UNITED STATES
NUCLEAR REGULATORY COMMISSION
WASHINGTON, D.C. 20555-0001

SUBJECT: SHEARON HARRIS NUCLEAR POWER PLANT, UNIT 1 – STAFF
ASSESSMENT OF RESPONSE TO 10 CFR 50.54(f) INFORMATION
REQUEST FLOOD CAUSING MECHANISM REEVALUATION (TAC NO.
MF1103)

STAFF ASSESSMENT BY THE OFFICE OF NUCLEAR REACTOR REGULATION
RELATED TO FLOODING HAZARD REEVALUATION REPORT
NEAR-TERM TASK FORCE RECOMMENDATION 2.1
SHEARON HARRIS NUCLEAR POWER PLANT, UNIT NO. 1
DOCKET NO. 50-400

Figure 3.1-1. Locations of Main and Auxiliary Dams and Reservoirs in the Buckhorn Creek Drainage, and Sub-basins Used for the Flooding Analyses from Stream and Rivers.

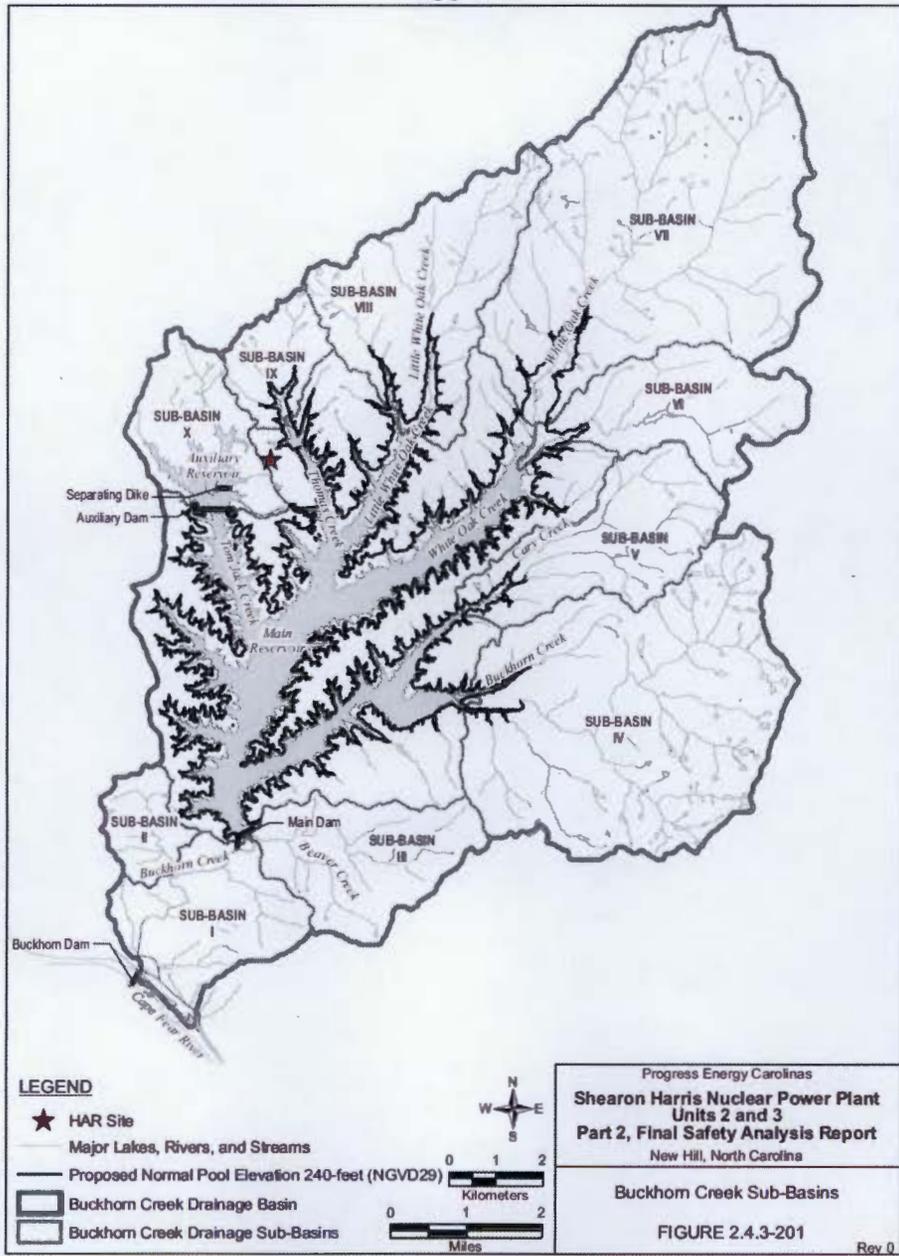
The FHRR identified the Buckhorn Creek watershed, with an area of 70.3 mi² (182.1 km²), as the primary drainage upstream of the Main Dam, as shown on Figure 3.1-1. Figure 3.1-1 also shows the Auxiliary Dam, which discharges to the Main Reservoir upstream of the Main Dam, and has a watershed of 3 mi² (8 km²).

Figure 3.2-1. Locations of Buildings, Subbasins, and Cross Sections in the HNP Unit 1 Site Hydraulic Model

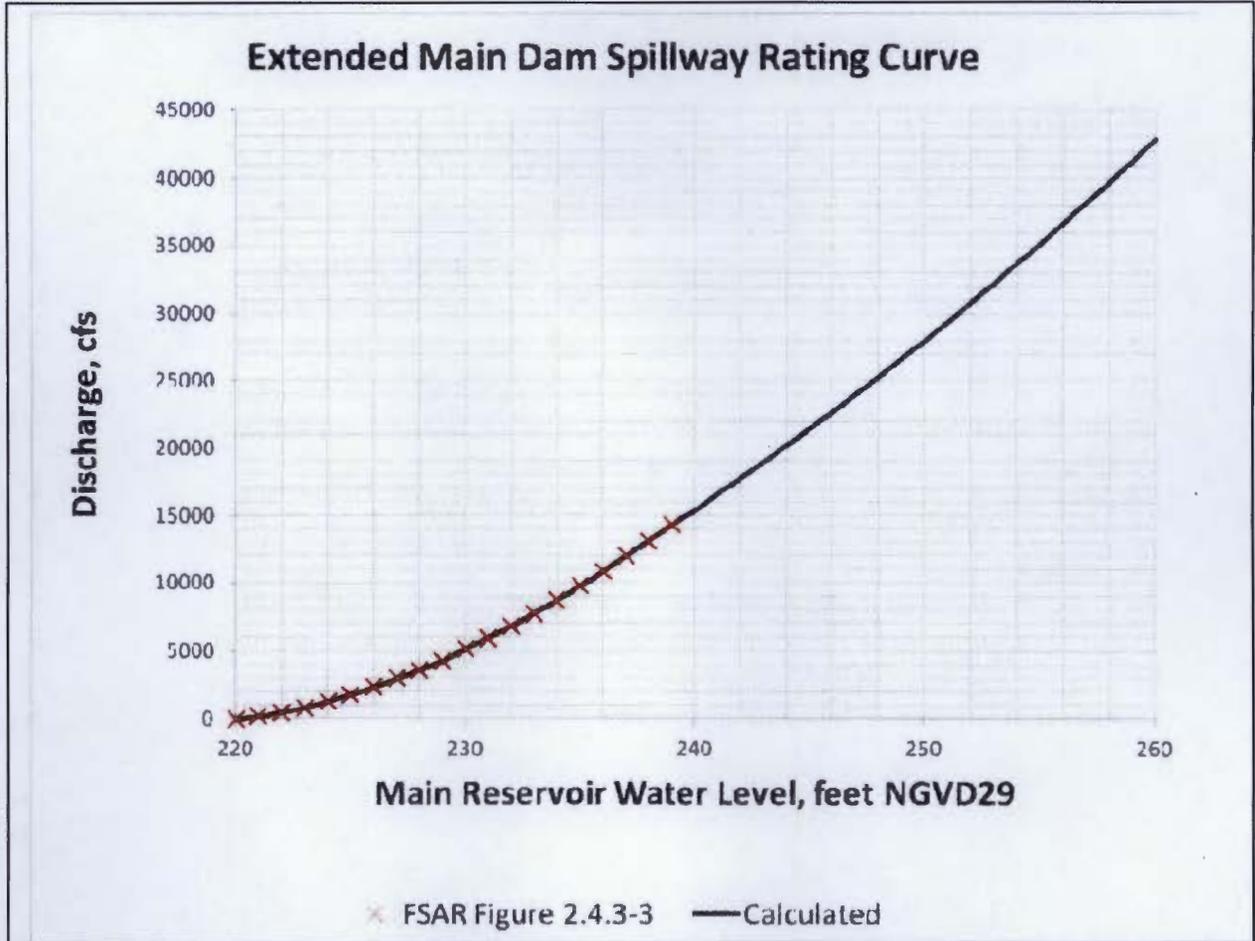
The FHRR described four areas (i.e., subbasins 5, 6, 8, and 16; Figure 3.2-1) with sumps and containment areas that would retain all runoff and excluded the runoff contribution from these subbasins in its LIP flood analysis. The four areas described by the licensee (Duke, 2013 and Duke, 2014b) are expected to retain the building runoff from the LIP event in sumps, or in containment areas located between retaining walls.

For the storage areas with sumps (subbasins 5, 6, and 16; Figure 3.2-1), the licensee stated that when the storage volume of each sump is filled to an elevation of 261 ft (79.6 m), any additional runoff will spill onto the site. For the containment volume in the Tank Building (subbasin 8; Figure 3.2-1), which is between the Tank Building and the walls that enclose the building area, the licensee states that the storage volume will contain all of the LIP runoff from the building (Duke, 2014b). The top of the wall is 286 ft (87.2 m) and the invert between the walls is 261 ft (79.6 m) (Duke, 2014b). According to the licensee (Duke, 2014b), the LIP will fill the Tank Building storage to an elevation of 276.1 ft (84.16 m), which the staff estimated is only 60 percent of the total storage capacity. The staff considered the possibility that storm events with longer durations and hence, larger accumulated depths, could also occur, which is the case for the basin-wide PMP examined in Section 3.3.

The FHRR stated that a HEC-RAS hydraulic model of the site was developed for the LIP analysis and was applied to route the runoff from the subbasins along the estimated flow paths. As discussed below, the staff reviewed the cross-section information contained in the model's input file. The locations of the model's cross-sections are shown in Figure 3.2-1.
